ISO/IEC JTC1/SC2/WG2
Coded Character Set
Secretariat: Japan (JISC)

Doc. Type: Draft disposition of comments

Title: Draft disposition of comments on ISO/IEC CD 10646 5th edition

Source: Michel Suignard (project editor)

TE.5. 33.5 Code charts and lists of character names – New G sources

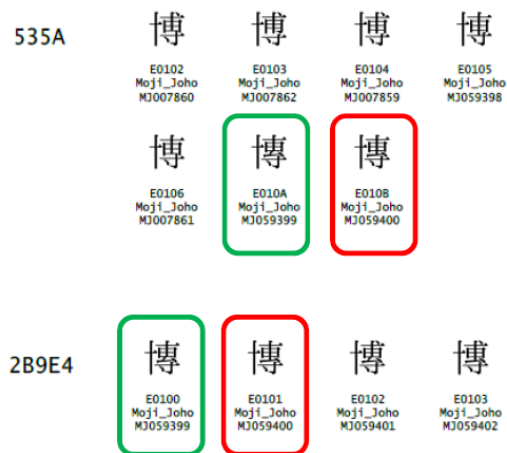
As proposed in ISO/IEC JTC 1/SC 2/WG 2 N4988, the source reference in G column of following CJK unified characters are changed.

- from GKX-0631.02 to GHZ-31665.01 for U+3CFD
- from GE-313D to GZFY-28665 for U+6FF9
- from GE-3952 to GLK-421274 for U+809E
- from GE-3D37 to GHZR-63304.09 for U+891D

- The source reference is normative information and this change may cause the compatibility problem on the data transformation table with existing implementation, therefore this change should be avoided.

Do not change the source reference of these 5 glyphs on G column.
